RESPONSE

A retrofit hurricane tie that connects the roof to the exterior walls on an existing building. Parallel webs allow attachment to opposite sides of a roof rafter, and a perpendicular base member allow attachment to the outside wall. An offset web, and unique bends between the rafter webs and base member allow the connector to clear blocking and frieze boards beneath the roof.

FIG. 1

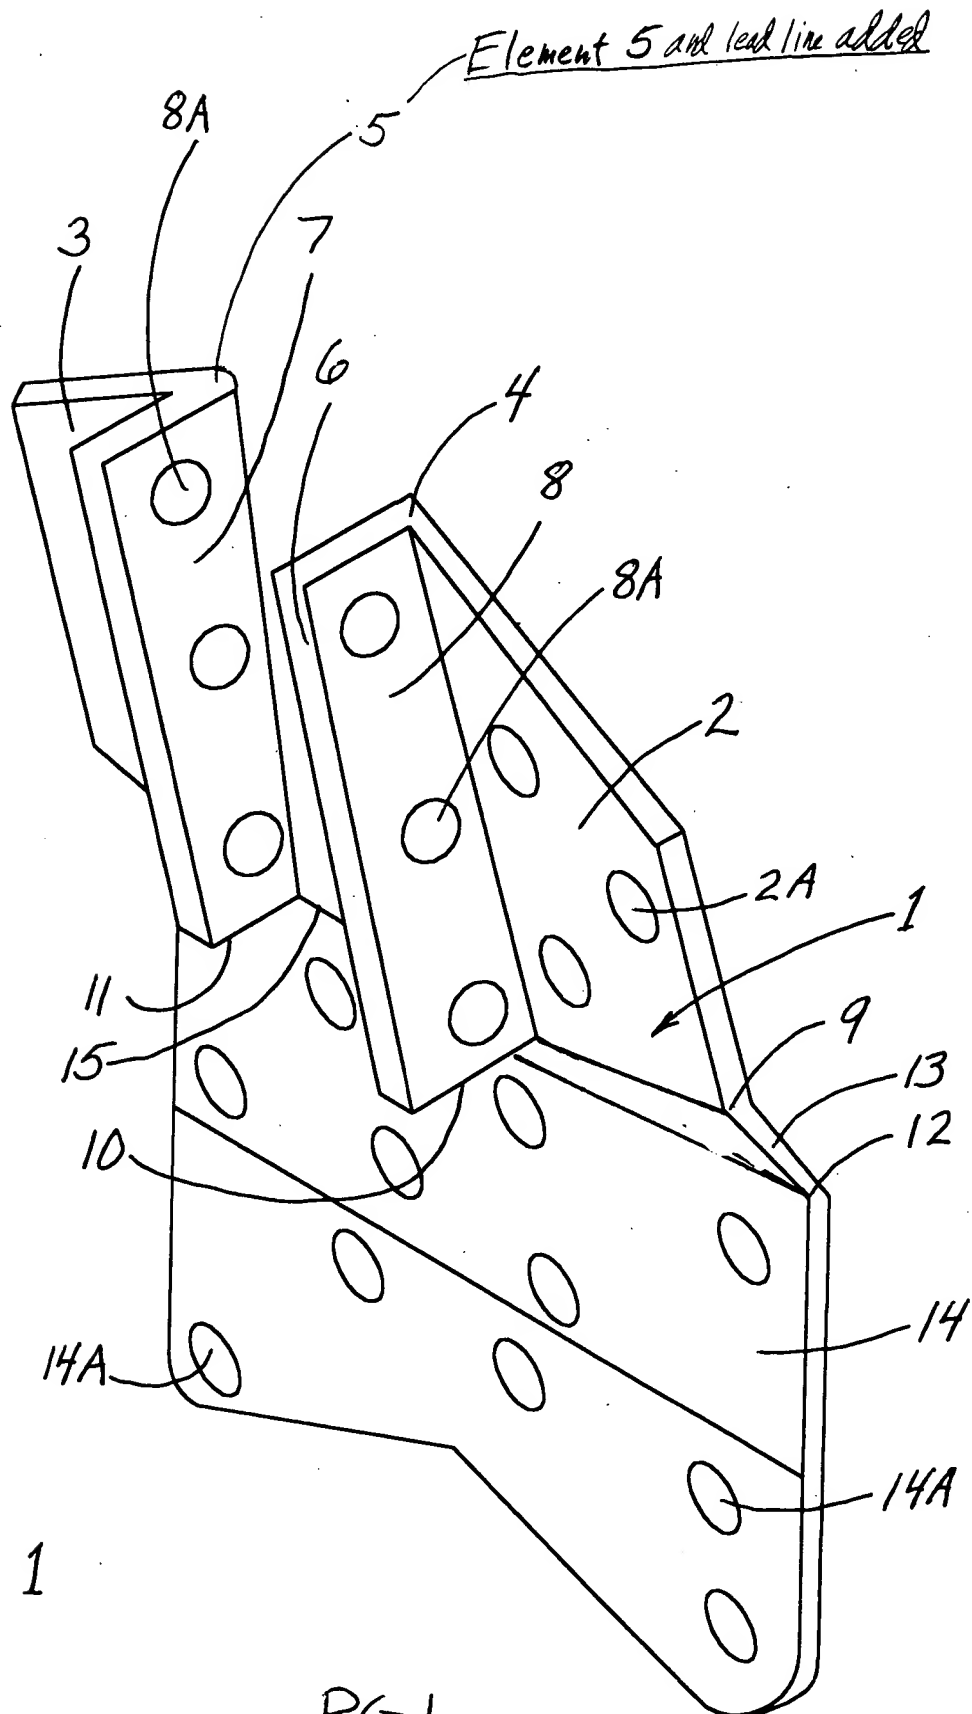
1. Add "Fig. 5A" to roof plate 39, shown on Fig. 5.
2. On Figs. 2, 3, and 6, change the bracket referring to the top plate to a lead line.
3. On Figs. 3, 4, and 5, change the bracket referring to the seat 15.
4. On Fig. 6, delete reference numerals 44 and 45, and their lead lines.
5. On Fig. 1, add reference numeral 5 and lead line.

FIG. 2

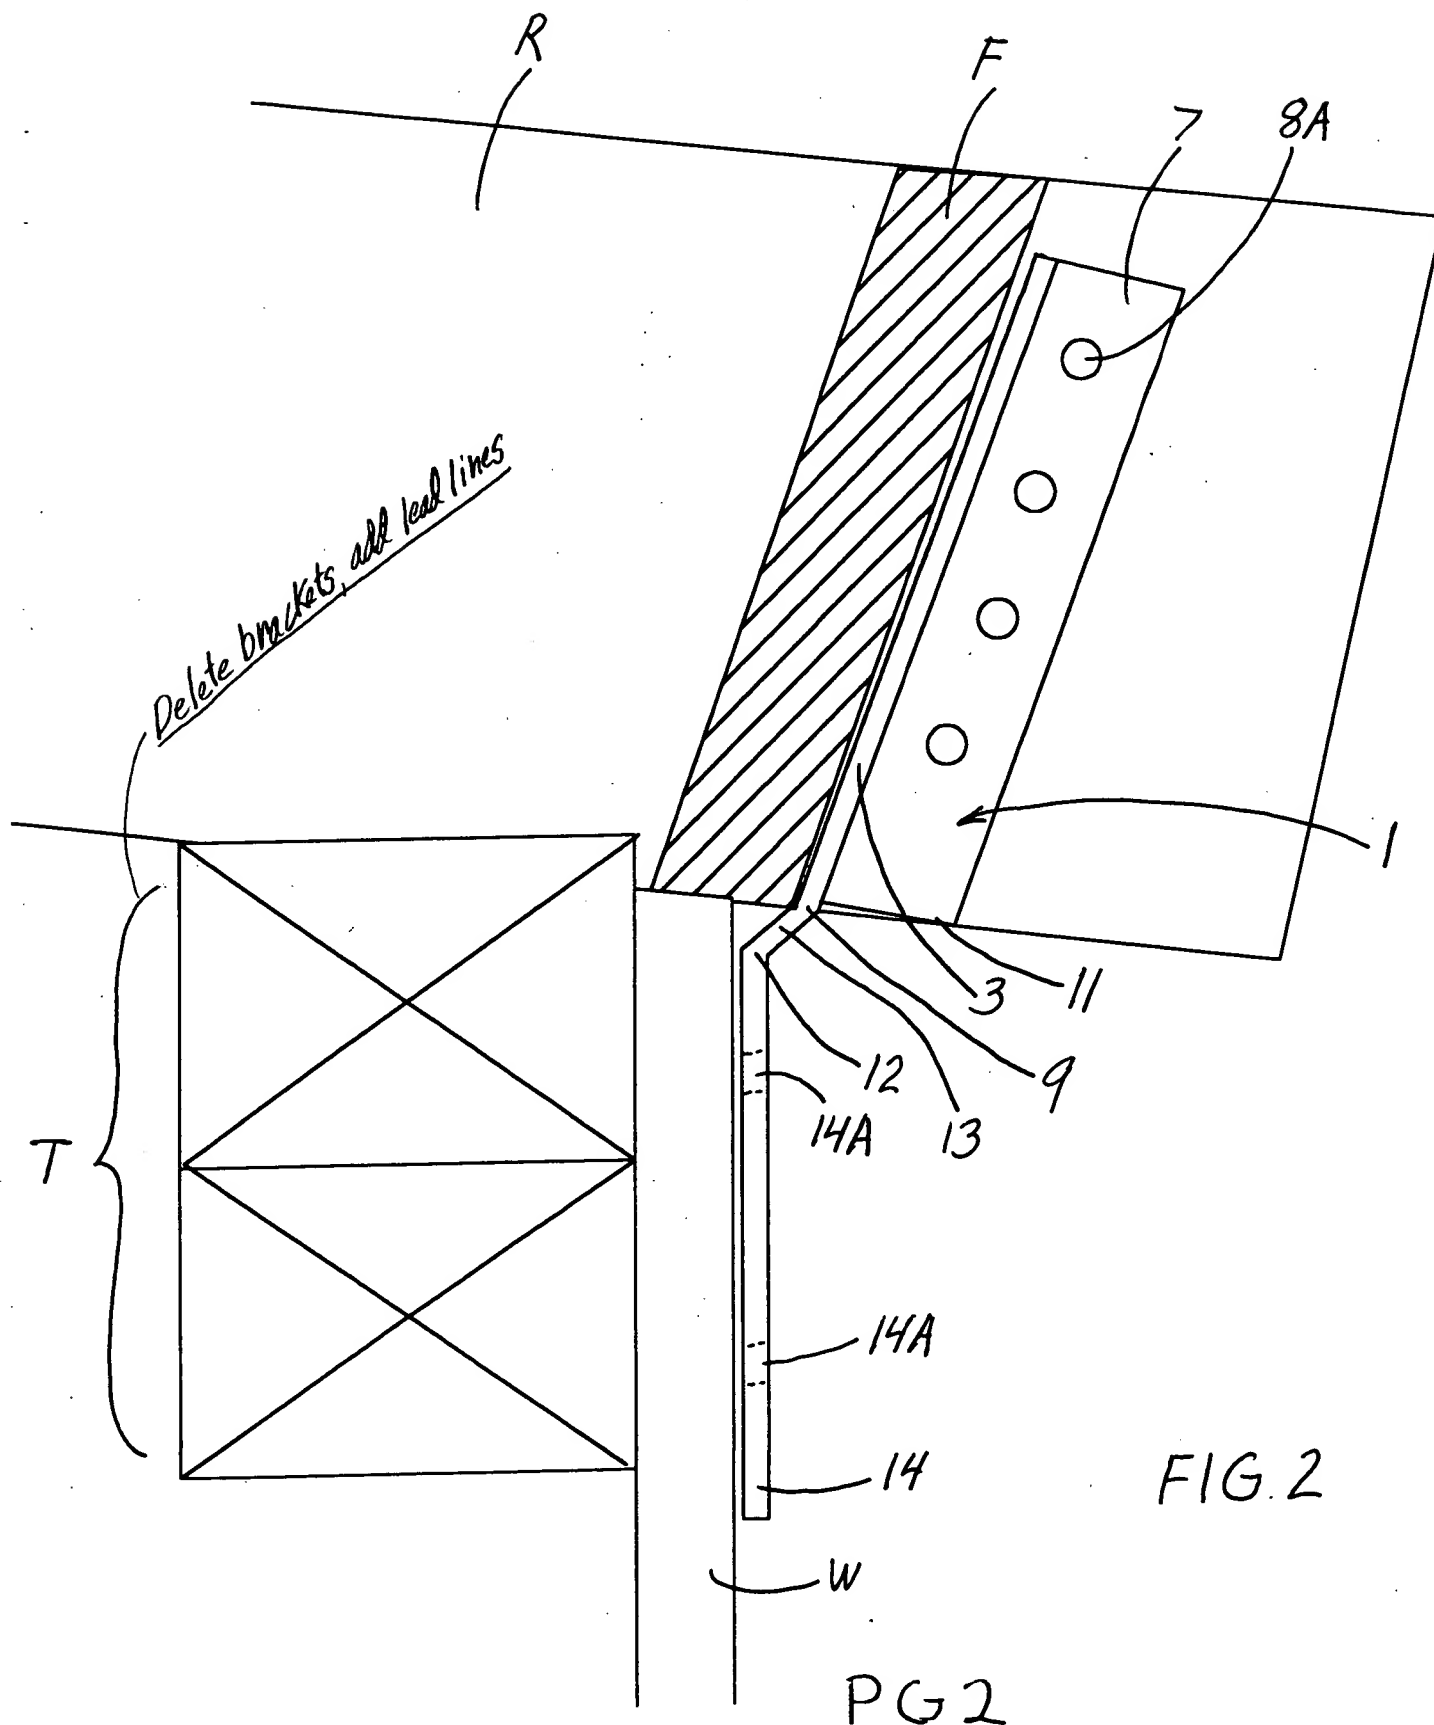
4. **The bracket shown adjacent to reference character “T” in Figures 2 and 6 is misleading. Is “T” depicting top plates or a top plate? Applicant should consider using lead lines as brackets are only used to show the components that belong to an exploded figure.** Standard practice for exterior wall framing is to use a double top plate. The applicant patterned the invention for his post-and-beam home, which uses a singular thick beam for the top plate. The invention can be used on a single beam, or a double top plate. The important function is that the retrofit invention can attach to the underlying structural top plate, from the outside of the house, by nails going through the outside sheathing. With the brackets on the drawings, the applicant intended the double members to be considered the “top plate”. The applicant will delete the top plate brackets and add lead lines on Figs. 2, 3, and 6, and delete cut line brackets on Figs. 3, 4, and 5..

FIG 5

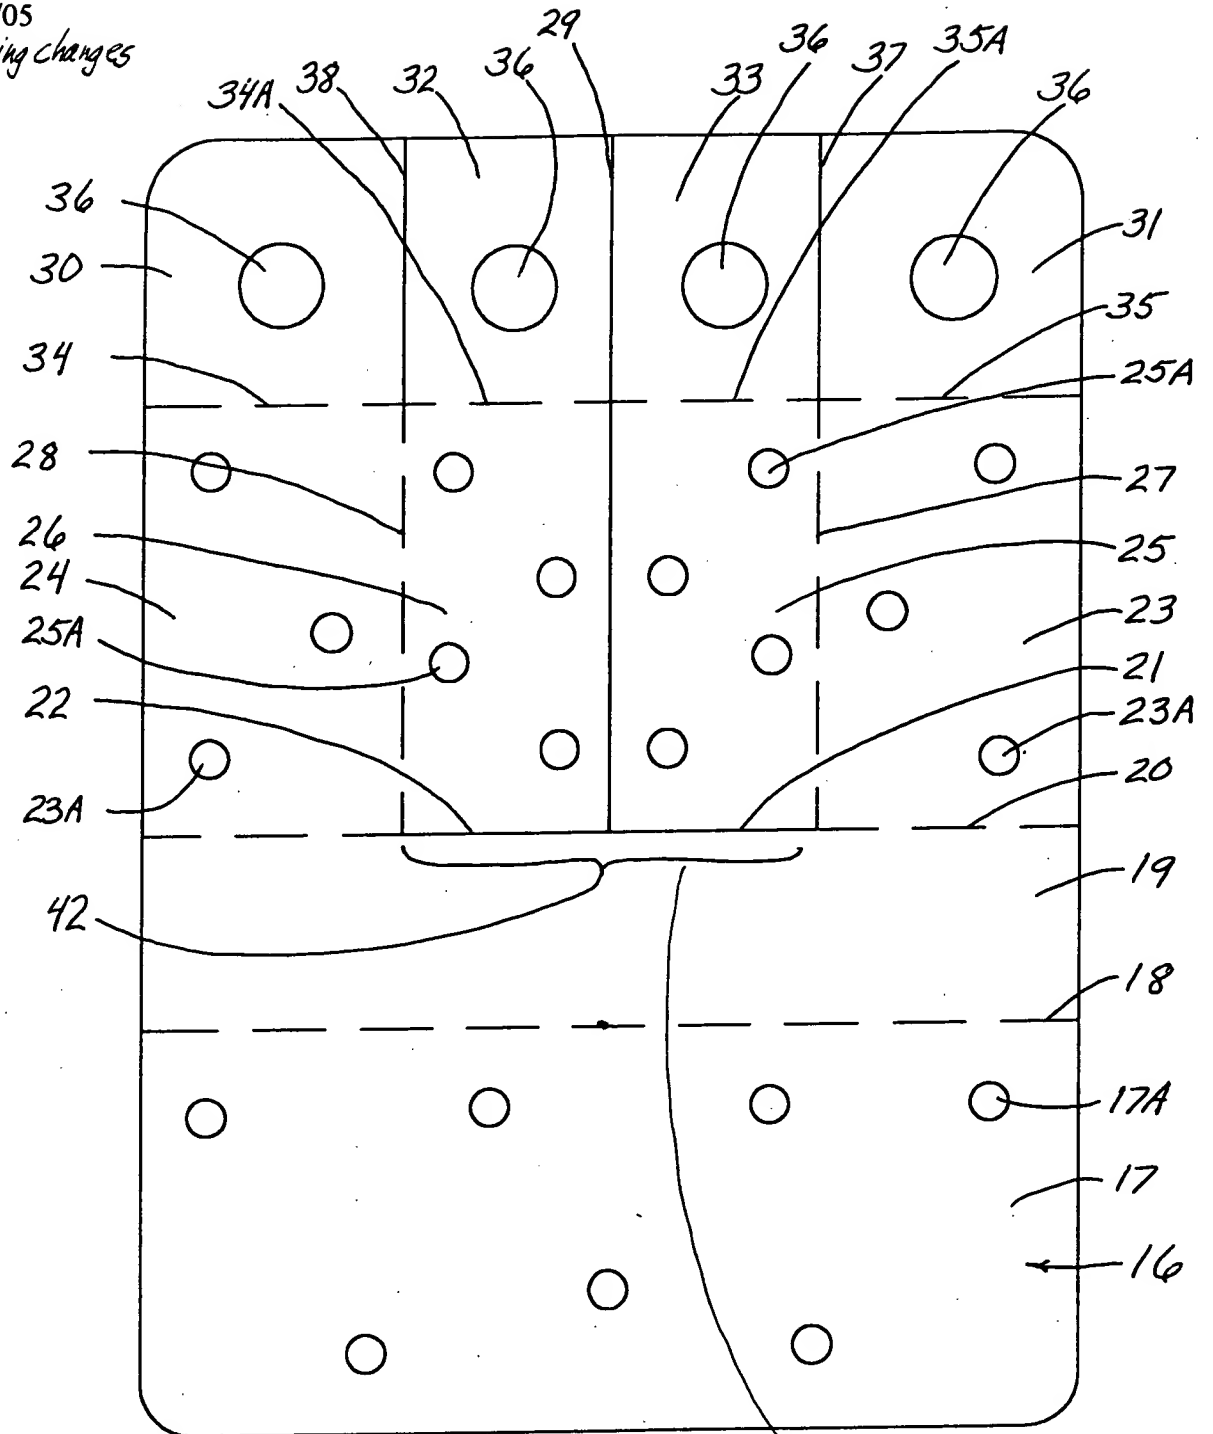
2. **The drawings are objected to as failing to comply with 37 CFR 1.84(p)(4) because reference characters "39" and "40" in Figure 5 have been used to designate the same plate. The roof plate 39 shown on Fig. 5 should be a separate figure. The applicant has designated the roof plate 39, as Fig. 5A. The applicant wanted the reference character "39" to refer to the whole roof plate, hence the arrow on the lead line. The applicant intended the reference character "40" to refer to the top surface of the roof plate.**

Delete bracket,  
Add lead lines
